Re: FLL Runway Geometry Update – Record of Changes

Fort Lauderdale/Hollywood International Airport (FLL) Runway Geometry Update (RGU):

Re: FLL Airport Layout Plan Update – Record of Changes

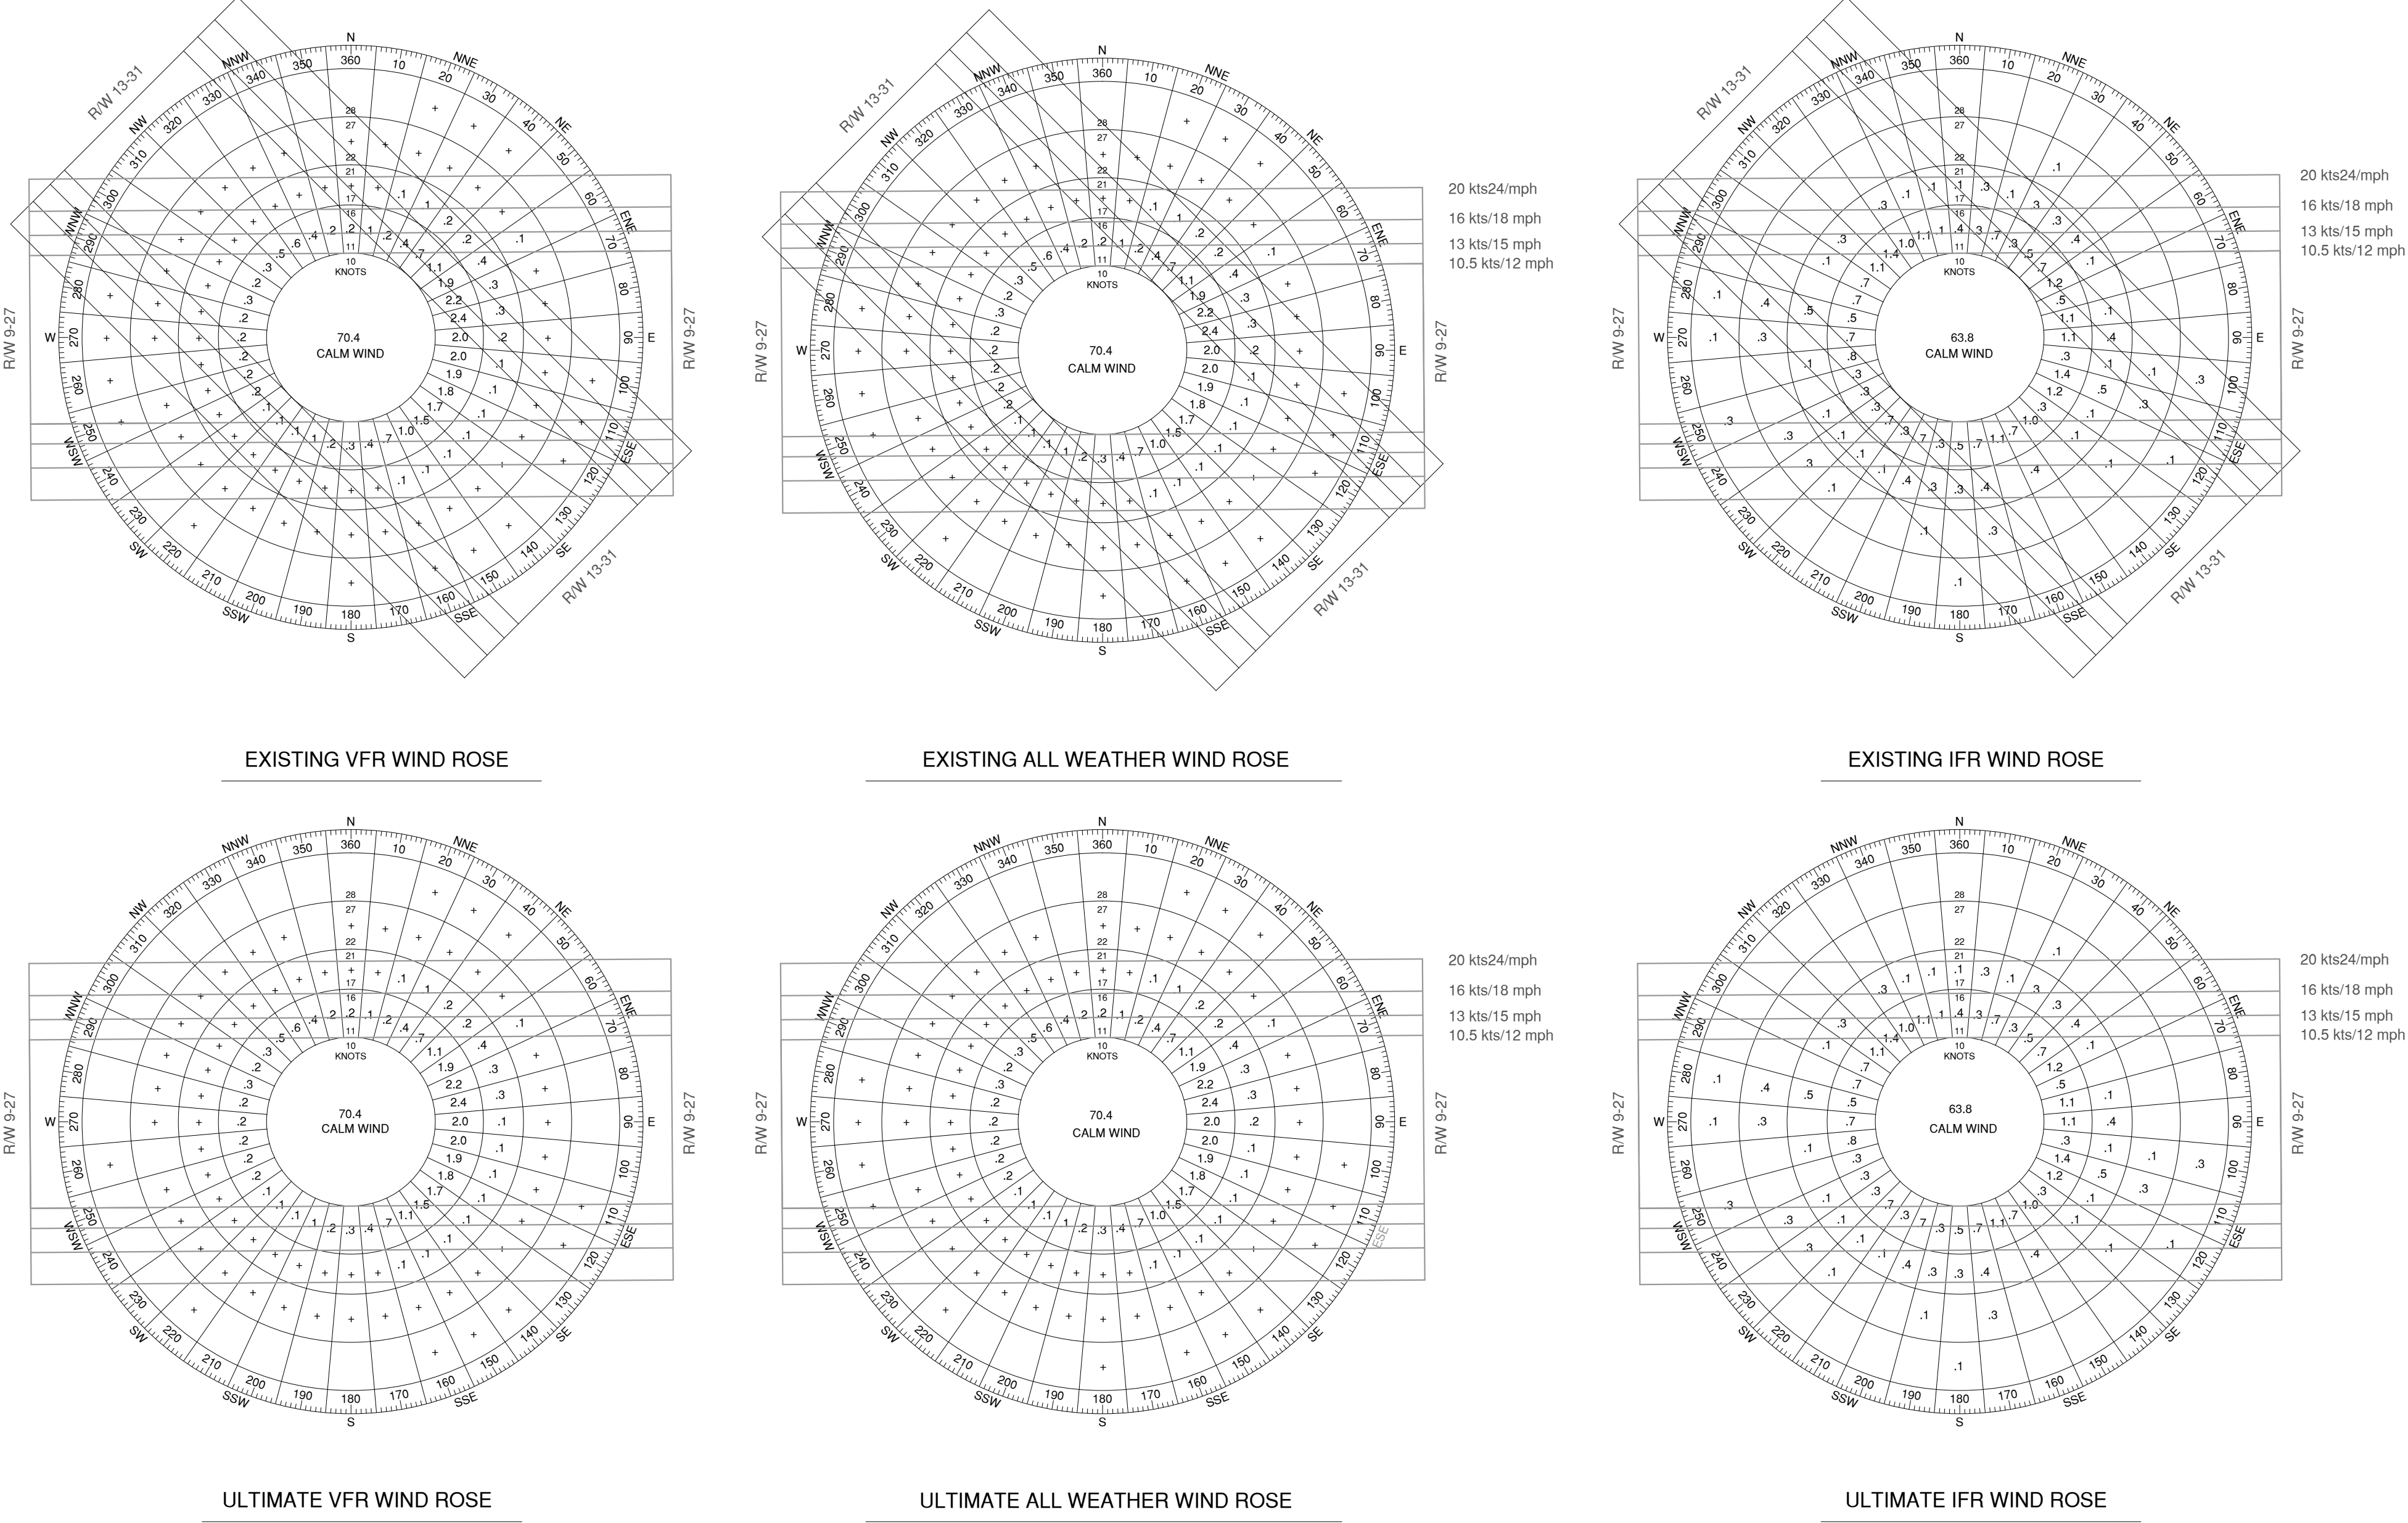
- 44. Added Taxiway/Taxilane Data Table
- 45. Updated Data Sheet notes as appropriate
- 46. Updated the following data elements:
 - NAVAID facility information
 - Existing and future building numbers and names
 - Existing and future building elevations
 - Runway coordinates and associated elevations
 - Magnetic declination
 - Critical Aircraft and Design Group
 - Future ARP
 - Airport Data Tables
 - Runway Data tables
